SUBJECT: INDIAN POINT NUCLEAR GENERATING UNIT NO. 3 – ISSUANCE OF
AMENDMENT NO. 272 RE: REVISION TO LICENSING BASIS TO
INCORPORATE THE INSTALLATION AND USE OF A NEW AUXILIARY
LIFTING DEVICE (EPID L-2020-LLA-0051)

Amendment No. 272
License No. DPR-64

NON-PROPRIETARY SAFETY EVALUATION FOR
AMENDMENT NO. 272 TO RENEWED FACILITY LICENSE NO. DPR-64
HOLTEC DECOMMISSIONING INTERNATIONAL, LLC AND
HOLTEC INDIAN POINT 3, LLC
INDIAN POINT NUCLEAR GENERATING UNIT NO. 3
DOCKET NO. 50-286

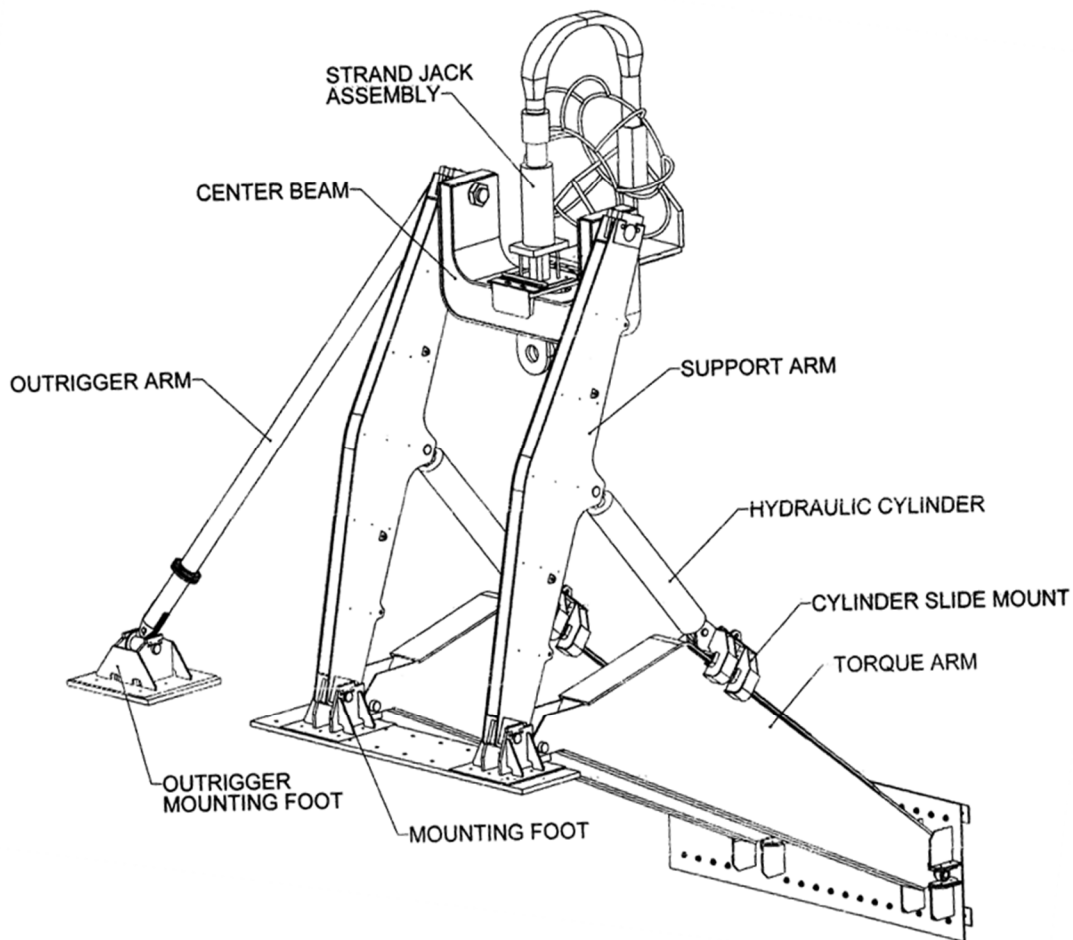
The proposed HI-LIFT would be credited as a single-failure-proof lifting device with a critical load rating of 100-tons. The lifting device would be a strand jack assembly pivoting on support arms mounted to the top of the south wall of the IP3 SFP and positioned by hydraulic cylinders acting against a torque arm. The following diagram provides an isometric view of the lifting device:

The licensee included the following diagram of a strand jack device as Figure 2 in Attachment 1 to the enclosure provided in the license amendment request:

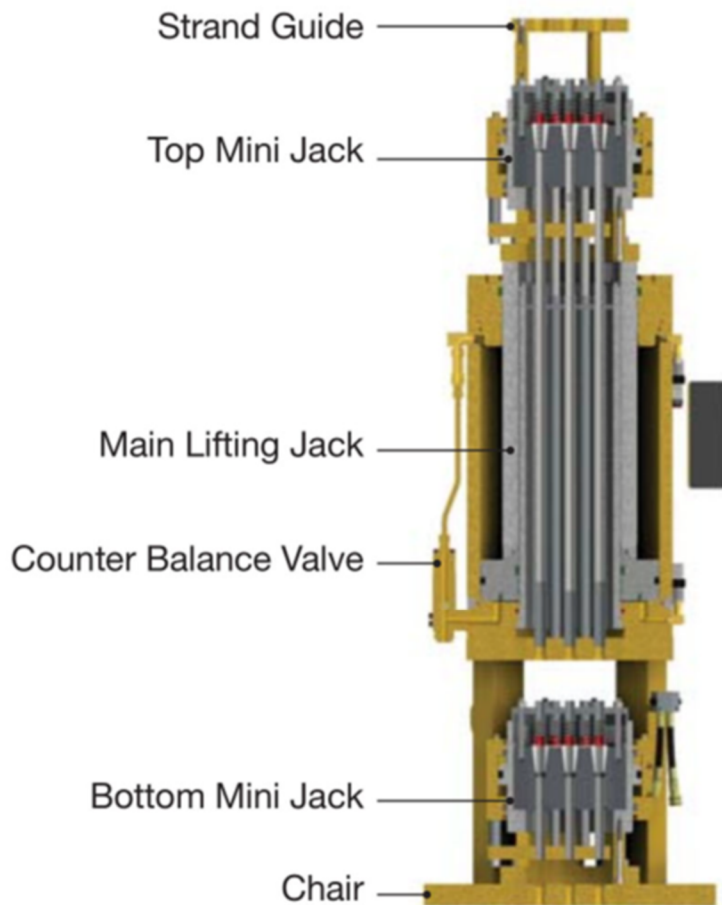
The licensee established design criteria for the strand jack system to support reliable operation. The licensee included certain design criteria in the HI-LIFT design specification, HI-2188549,

]]. The licensee stated that the strand jack design provides effective load sharing among redundant components, particularly the strands and wedges. The independent capability of each anchor block to support the load, in combination with the design of the strand jack that separates functions, permits a number of components that are essential to lowering the suspended load to be repaired or replaced while the load is suspended from one of the anchor blocks. The licensee addressed these capabilities in detail in the FMEA tables.

Overall, the NRC staff determined that the design proposed for the strand jack provides reasonable assurance that equipment important to safety would be appropriately protected from equipment failures affecting the strand jack, thereby satisfying GDC-4. The licensee has developed a commercial grade dedication program and identified appropriate pre-operational tests to verify the adequacy of the design and fabrication of the strand jack, which satisfies GDC-1. The structural design satisfies GDC-2. Therefore, the NRC staff found the strand jack design acceptable for the purpose of HI-TRAC transfer cask handling operations at IP3.
